Access Audit Site Report

Cooper Lake State Park - South Sulphur Unit

Accessibility Evaluation

Inspection Date: 10/19/2021

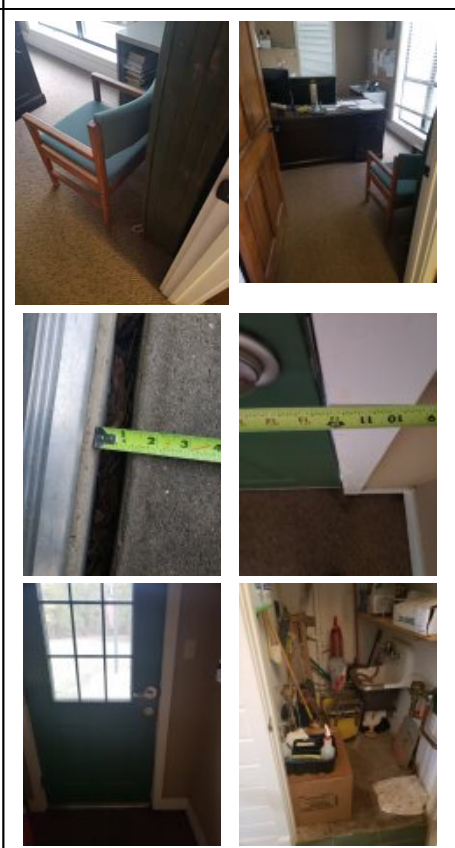
Finding Number	Area Description	Lat/Long	Finding	As Built	Recommendation	Citation	Photos	Figure
6	Headquarters Area: HQ Exterior Accessible Route	[33.2879605, -95.658248]	There is a gap spaced greater than a 1/2 inch. Openings in floor or ground surfaces shall not allow passage of a sphere more than 1/2 inch diameter. Elongated openings shall be placed so that the long dimension is perpendicular to the dominant direction of travel.	1" gap along side lot, 1" gap by accessible parking on side, on residence end in center of path - 1" gap, .75" gap at left corner of path, 3" gap going towards firewood lockers at corner, .75" gap at corner by firewood	Correct or fill gaps to be max .5"	2015 ABAAS Section: 302.3 2012 TAS Section: 302.3 2010 ADAS Section: 302.3

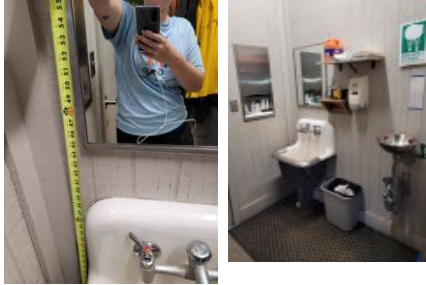
Finding Number	Area Description	Lat/Long	Finding	As Built	Recommendation	Citation	Photos	Figure
32	Headquarters Area: HQ Womens Restroom	[33.2877453, -95.657914]	The hand dryer projects more than 4 inches into the circulation path. Wall-mounted objects that have leading edges between 27 inches and 80 inches from the floor must not project more than 4 inches into the circulation path. Protruding objects that extend to the floor or within 27 inches of the floor are cane detectable and are therefore not hazardous. Where it is necessary or desirable to have objects protrude from the wall, a manner of cane detection must be provided.	5" hand dryer	Relocate protruding objects or place cane detectable warning or bollard at foot of item	2015 ABAAS Section: 307.2 2012 TAS Section: 307.2 2010 ADAS Section: 307.2		
33	Headquarters Area: HQ Womens Restroom	[33.2877363, -95.6579301]	The accessible route contains running slopes greater than 5 percent and cross slopes greater than 2 percent across the width of the walk and has not been constructed as a ramp (i.e. handrails, wheel guides, etc.). When the slope in the direction of travel of any walk exceeds 1 unit vertical in 20 units horizontal (5-percent slope), it must be constructed as ramp. Surface cross slopes must not exceed one unit vertical in 48 units. Horizontal (2-percent slope).	3.7% cross slope in front of toilet	Correct or repair slope to max 2.08% in restroom.	2015 ABAAS Section: 403.3 2012 TAS Section: 403.3 2010 ADAS Section: 403.3

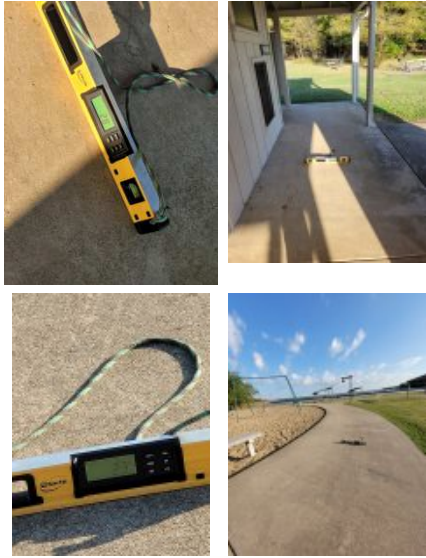
Finding Number	Area Description	Lat/Long	Finding	As Built	Recommendation	Citation	Photos	Figure
57	Heron Harbor Day Use Area: HH - Exterior Accessible Route	[33.2928202 , -95.652359 2]	The accessible route of travel on the accessible route contains cross slopes greater than 2%. Cross slopes shall not exceed one unit vertical in 48 units horizontal (2-percent slope).	3.7% cross slope on path by basketball court	Correct or repair cross slope along AR to max 2.08%	2015 ABAAS Section: 403.3 2012 TAS Section: 403.3 2010 ADAS Section: 403.3		
58	Heron Harbor Day Use Area: HH - Exterior Accessible Route	[33.2922317 , -95.65242 62], [33.2933448 , -95.652325 6]	There is a gap spaced greater than a 1/2 inch. Openings in floor or ground surfaces shall not allow passage of a sphere more than 1/2 inch diameter. Elongated openings shall be placed so that the long dimension is perpendicular to the dominant direction of travel.	8" gap from lot to path. where path/sidewalk turns towards lake and picnic - 4" gap at turn. between picnic - 4" gap. 2nd single covered picnic from dam - 2" gap on path in front. after 2nd single shelter to dam 2" gap on path. 1" gap on top corner by dam. in front of wood short pier in cove - 1.5" gap	Correct or fill gaps to be max .5"	2015 ABAAS Section: 302.3 2012 TAS Section: 302.3 2010 ADAS Section: 302.3

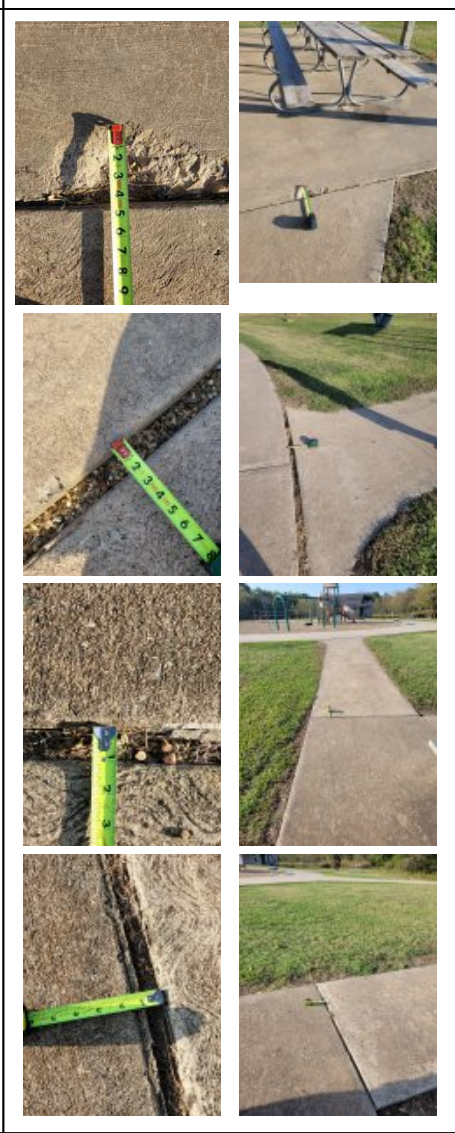
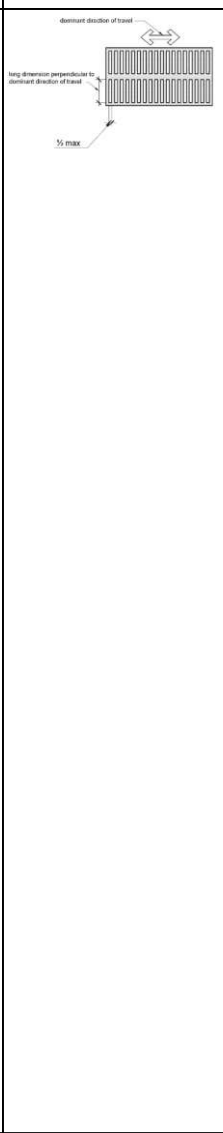
Finding Number	Area Description	Lat/Long	Finding	As Built	Recommendation	Citation	Photos	Figure
62	Heron Harbor Day Use Area: HH - Exterior Accessible Route	[33.2916196, -95.6521339], [33.2918696, -95.6518026]	There is a gap spaced greater than a 1/2 inch. Openings in floor or ground surfaces shall not allow passage of a sphere more than 1/2 inch diameter. Elongated openings shall be placed so that the long dimension is perpendicular to the dominant direction of travel.	1.5" gap on women's side of restroom building, 1" on men side entry. 2" gap at entry to swimming	Correct or fill gaps to be max .5"	2015 ABAAS Section: 302.3 2012 TAS Section: 302.3 2010 ADAS Section: 302.3

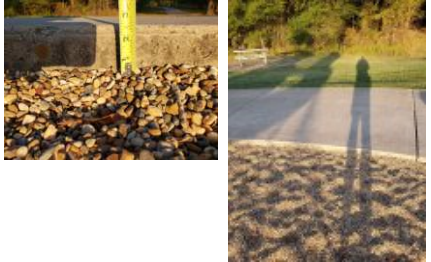
Finding Number	Area Description	Lat/Long	Finding	As Built	Recommendation	Citation	Photos	Figure
63	Heron Harbor Day Use Area: HH - Exterior Accessible Route	[33.2918763, -95.6517825]	The walkway contains abrupt vertical edges and/or variations over a 1/4 inch. 1/4 inch is the maximum vertical rise. Changes in level between 1/4 inch and 1/2 inch must be beveled at 1:2 or less. Changes in level greater than 1/2 inch must be by way of a ramp.	2" CIL at turn to swimming by swing side	Repair, bevel or ramp CIL along AR	2012 TAS Section: 303.2, 303.3 2010 ADAS Section: 303.2, 303.3		
64	Heron Harbor Day Use Area: HH - Exterior Accessible Route	[33.2918786, -95.6517677]	The running slope of walking surfaces shall not be steeper than 1:20.	5.7% slope on path to swimming	Correct running slope along the AR to max 5%	2015 ABAAS Section: 403.3 2012 TAS Section: 403.3 2010 ADAS Section: 403.3		
65	Heron Harbor Day Use Area: HH - Exterior Accessible Route	[33.2918999, -95.6516953], [33.2919638, -95.6515867]	There is a gap spaced greater than a 1/2 inch. Openings in floor or ground surfaces shall not allow passage of a sphere more than 1/2 inch diameter. Elongated openings shall be placed so that the long dimension is perpendicular to the dominant direction of travel.	1.25" gap at entry to covered picnic by playground. 2" gap close to ramp beach access	Correct or fill gaps to be max .5"	2015 ABAAS Section: 302.3 2012 TAS Section: 302.3 2010 ADAS Section: 302.3

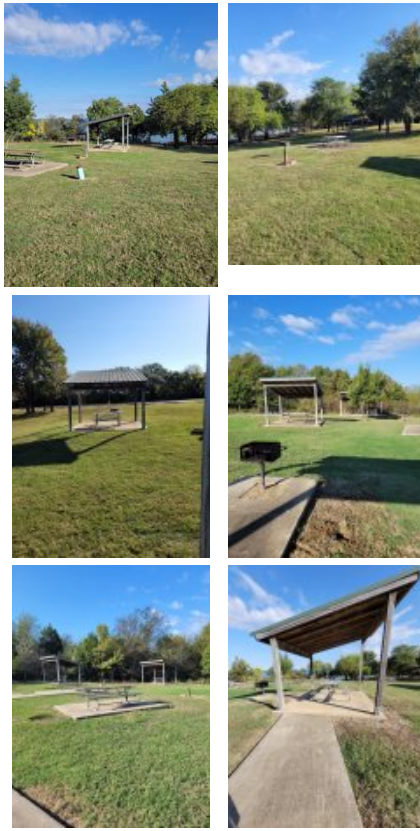
Finding Number	Area Description	Lat/Long	Finding	As Built	Recommendation	Citation	Photos	Figure
133	Gulls Bluff Day Use Area: GB - Fish Cleaning	[33.2938706, -95.6529546]	There is a gap spaced greater than a 1/2 inch. Openings in floor or ground surfaces shall not allow passage of a sphere more than 1/2 inch diameter. Elongated openings shall be placed so that the long dimension is perpendicular to the dominant direction of travel.	there is no marked route from accessible parking to fish cleaning path, 6" of overgrown grass at entrance	Correct or fill gaps to be max .5".	2015 ABAAS Section: 302.3 2012 TAS Section: 302.3 2010 ADAS Section: 302.3		
134	Gulls Bluff Day Use Area: GB - Fish Cleaning	[33.293745, -95.6529251]	The running slope of walking surfaces shall not be steeper than 1:20.	6.6% slope at path to fish cleaning	Correct running slope along the AR to max 5%	2015 ABAAS Section: 403.3 2012 TAS Section: 403.3 2010 ADAS Section: 403.3

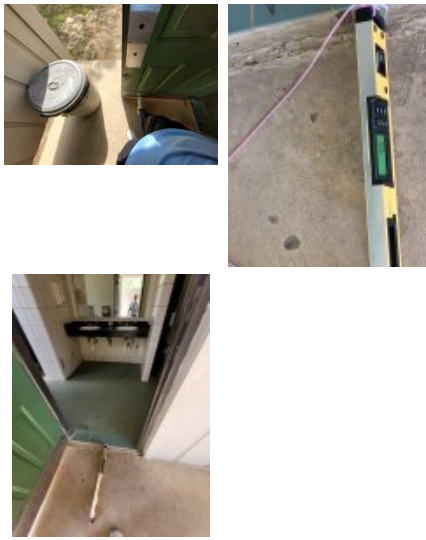
Finding Number	Area Description	Lat/Long	Finding	As Built	Recommendation	Citation	Photos	Figure
205	Eagle Point Shelters Area: EP - Women's Restroom	[33.2939558 , -95.6654054]	The bench is not deep enough or long enough or is missing. Benches shall be provided having seats that are 42 inches long minimum and 20 inches deep minimum and 24 inches deep maximum. The bench shall provide for back support or shall be affixed to a wall. Back support shall be 42 inches (1065 mm) long minimum and shall extend from a point 2 inches (51 mm) maximum above the seat surface to a point 18 inches (455 mm) minimum above the seat surface. Back support shall be 2½ inches (64 mm) maximum from the rear edge of the seat measured horizontally. The top of the bench seat surface shall be 17 inches (430 mm) minimum and 19 inches (485 mm) maximum above the finish floor or ground.	bench 28" wide	Replace bench in dressing area with one having a seat depth of 20" to 24" deep, 42" long, affixed to the wall or having a back and mounted 17" to 19" aff	2012 TAS Section: 903.4, 903.2, 903.3, 903.5 2010 ADAS Section: 903.4, 903.2, 903.3, 903.5

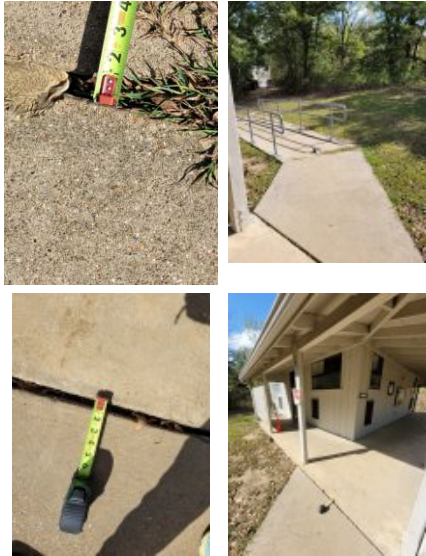
Finding Number	Area Description	Lat/Long	Finding	As Built	Recommendation	Citation	Photos	Figure
232	Sunset Cove Day Use Area: SC - Restroom	[33.2914201 , -95.665595 9]	The toilet is not located within the range allowed from the side wall or partition. The centerline of the toilet must be 16 to 18 inches from the side wall.	centerline of toilet is 34" from wall	Remount toilets to 16" to 18" from the side wall to centerline	2015 ABAAS Section: 604.2 2012 TAS Section: 604.2 2010 ADAS Section: 604.2		
233	Sunset Cove Day Use Area: SC - Restroom	[33.2914223 , -95.665594 5]	The toilet seat is not located within the range allowed off the floor. The height of accessible water closets shall be a minimum of 17 inches and a maximum of 19 inches measured to the top of a maximum 2-inch high toilet seat.	toilet seat - 19.25" aff	Replace toilet seat, or re-set or replace toilet to 17" to 19" aff	2015 ABAAS Section: 604.4 2012 TAS Section: 604.4 2010 ADAS Section: 604.4

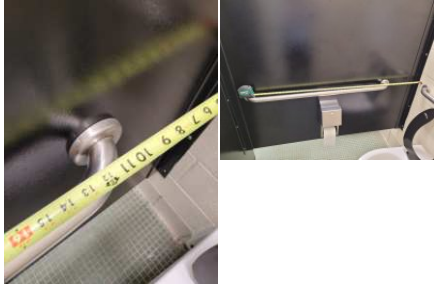
Finding Number	Area Description	Lat/Long	Finding	As Built	Recommendation	Citation	Photos	Figure
384	Buggy Whip Equestrian Camping Area: BW - Men's Restroom	[33.2874336 , -95.680981]	The grab bar height and/or spacing fails. Grab bars must be mounted between 33" and 36" to the top of the gripping surface. There must be 1.5" of clearance between the grab bar and the wall. There must be a minimum of 1.5" of clearance below and minimum 12" above the grab bar to any dispenser or other obstruction.	37.5" and 37" aff	Remount grab bars in accessible stall to 33" to 36" aff	2015 ABAAS Section: 609.3, 609.4 2012 TAS Section: 609.4, 609.3 2010 ADAS Section: 609.3, 609.4		
385	Buggy Whip Equestrian Camping Area: BW - Men's Restroom	[33.2874325 , -95.680986 4]	The stall door fails to comply with all of the door requirements. The stall door must be a minimum of 32" wide and have compliant hardware on both sides. The stall door must be self-closing.	stall door not self closing	Adjust stall door to be self-closing	2015 ABAAS Section: 404.2.3, 404.2.7, 604.8.2.2 2012 TAS Section: 404.2.3, 404.2.7, 604.8.2.2 2010 ADAS Section: 404.2.3, 404.2.7, 604.8.2.2
